BOARD OF ADJUSTMENT & APPEALS AGENDA

Date: August 19, 2024

REDUCTION OF THE FRONT YARD SETBACK & INSTALLATION OF A BULK STORAGE TANK WITHOUT A BERM

PLN24-10

CONCEPT PLAN

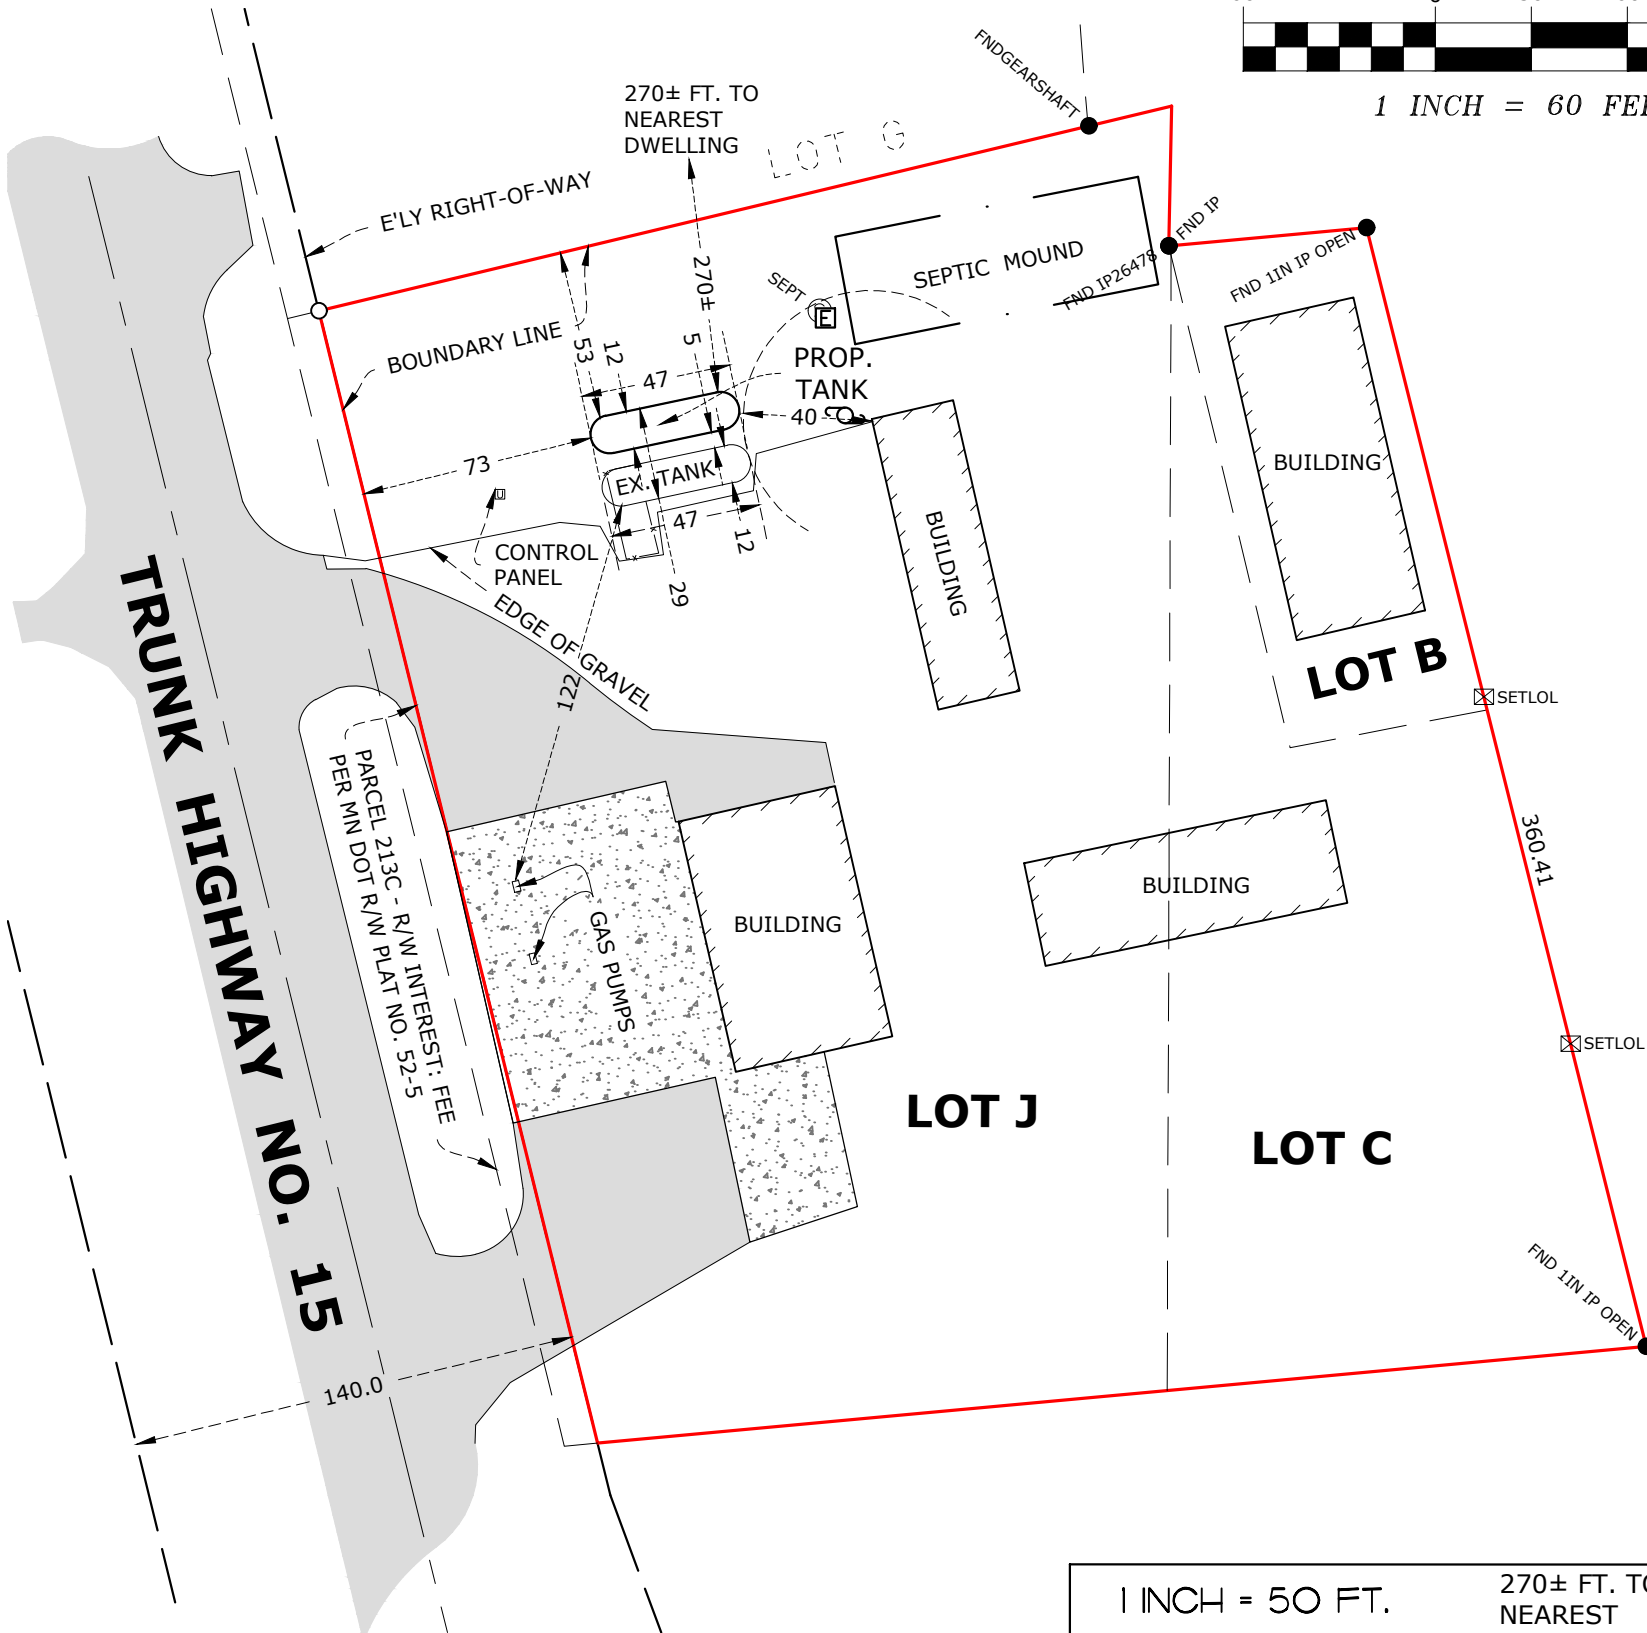
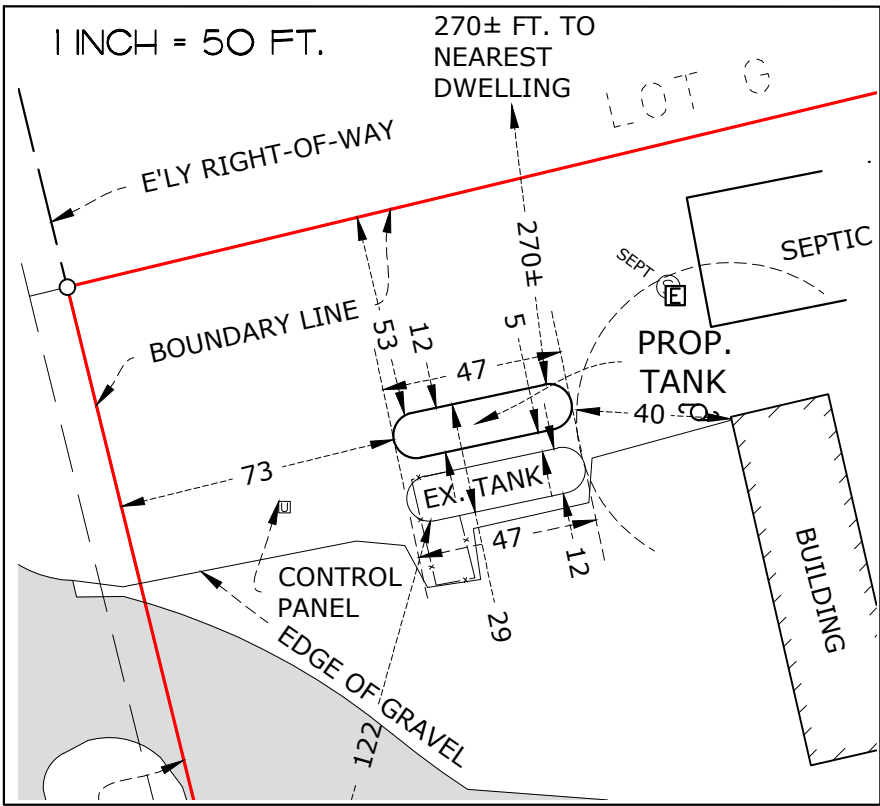
There are four large sheds, twelve liquid storage containers, multiple buried tanks, and a service station on the property. Given the 40-foot setback from structures as allowed by the New Ulm Fire Department and 100-foot right of way setback required by the Zoning Ordinance, there are limited locations in which the new tank could be placed. There appears to be other locations which could meet these requirements (particularly in the southwest of the property), but the Applicant has stated that placing a tank there would interfere with the loading and unloading of trucks. This is plausible as the south half of the property has several above and below ground storage tanks.

In regard to the second claim, the size of the right of way is not atypical for a State Highway. Moreover, it does not protrude into the UFC property any more so than the neighboring parcels. The right of way is a shared burden between all properties located along this part of Highway 15.

UFC has provided a letter from Arrow Tank and Engineering Company stating that there is no practical reason to construct a berm. The letter explains that propane has a boiling point of -44 F, meaning it would vaporize if spilled from the tank. Berming is not an industry practice for propane tanks.

1. The Applicant undertakes the project according to the plans and specifications submitted to the County with the application.
2. The County may enter onto the premises at reasonable times and in a reasonable manner to ensure the permit holder is in compliance with the conditions and all other applicable statutes, rules, and ordinances.
3. The Applicant must obtain the appropriate zoning permits prior to construction.
4. All planted landscaping shall be located outside of the MNDOT right of way and have a stem/trunk diameter of less than 4 inches.
